**CITY OF PORTLAND, MAINE**  
DEPARTMENT OF BUILDING INSPECTION

Re: 55 Riverside Street  
(Service Station)

Permit to construct a one-story masonry building 28'x45' as per plans submitted with application is being issued herewith and subject to the following being complied with:

Texaco Inc. Picnic Area - Riverside St. Portland Me  
 Scale 1/2" = 1'-0"  
 C.A. Simonds 10/20/70

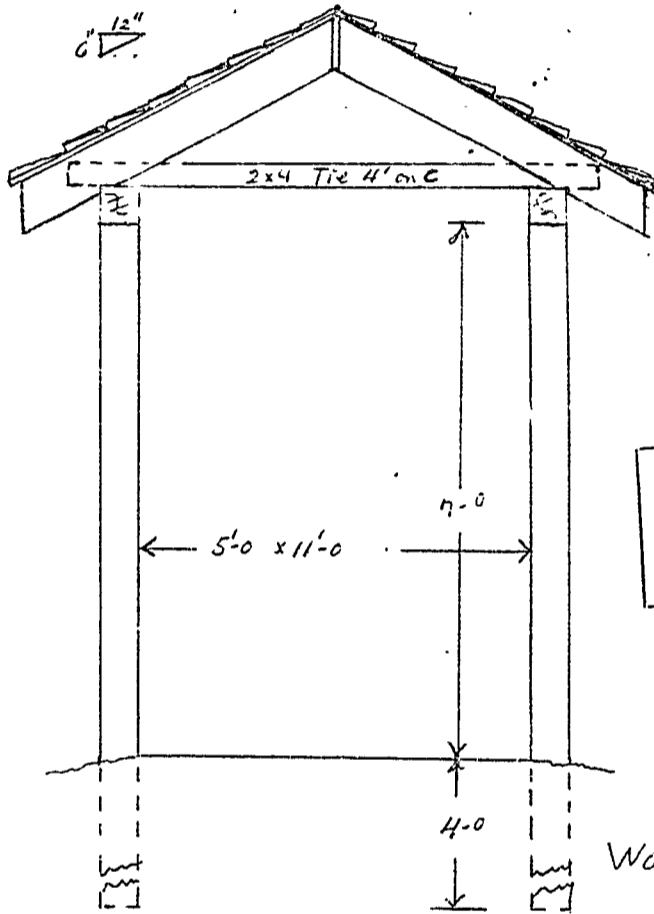
To construct 5' x 12' frame shelter as per plans.

Texaco, Inc. Sign  
 #55 Riverside Street, Portland, Me  
 Scale 1/2" = 1'-0"  
 C.A. Simonds 1/20/70

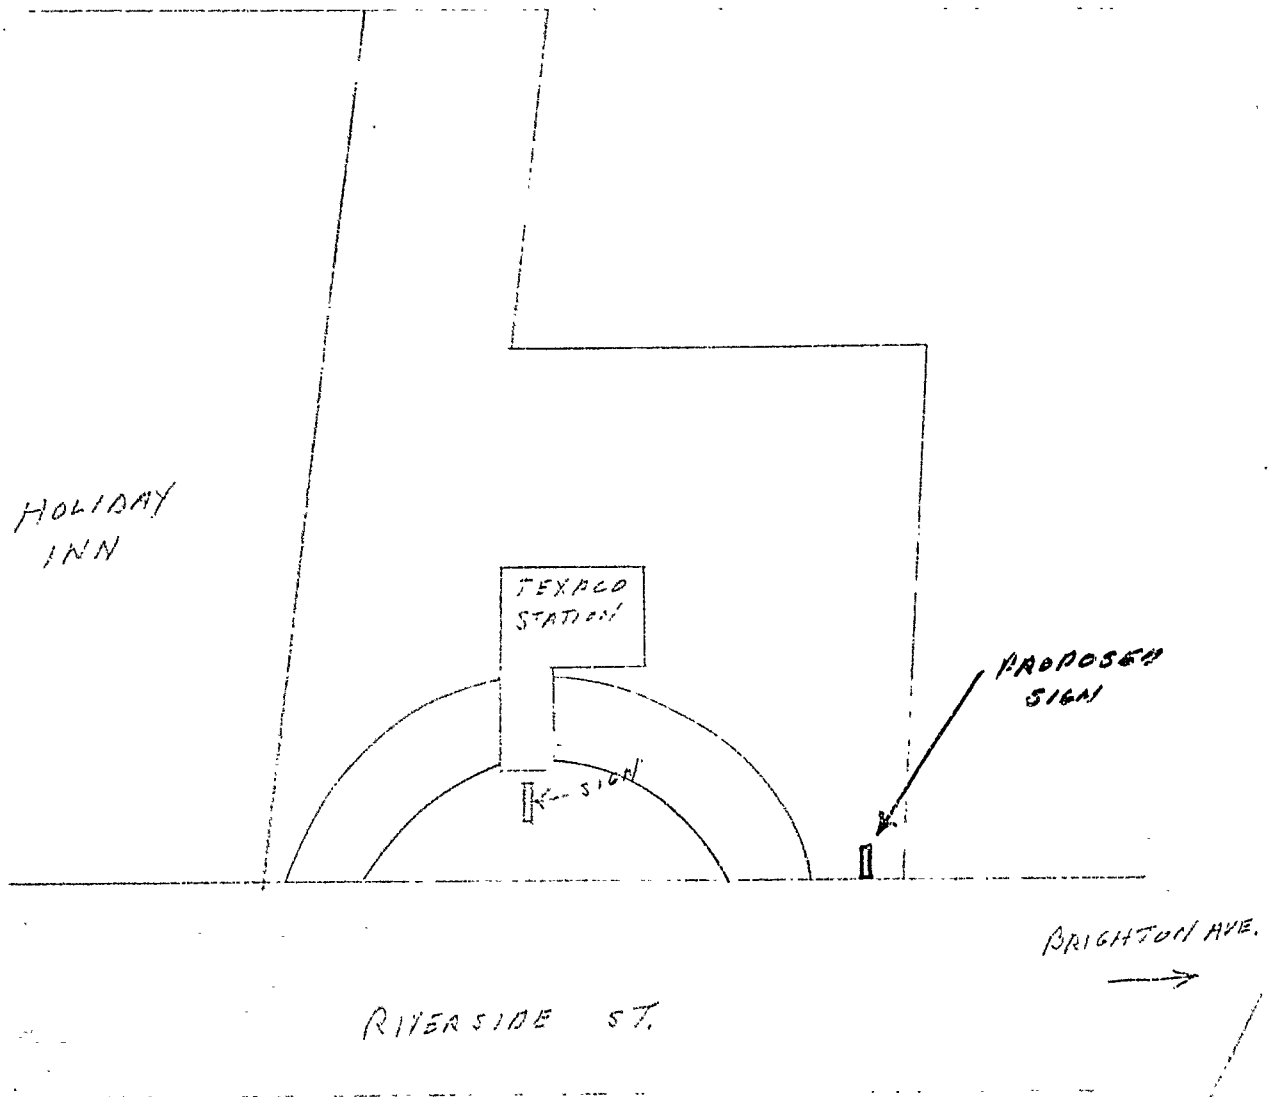
Building permit to erect a double-faced detached sign approximately 4'x7' with the top about 10' above the grade on the premises at the above named location is not issuable under the Zoning Ordinance because this sign which is to be located with the outer edge directly on the street line will be an unlawful encroachment upon the 40' setback area required by Section 602.21 for Riverside Street where this property is located.
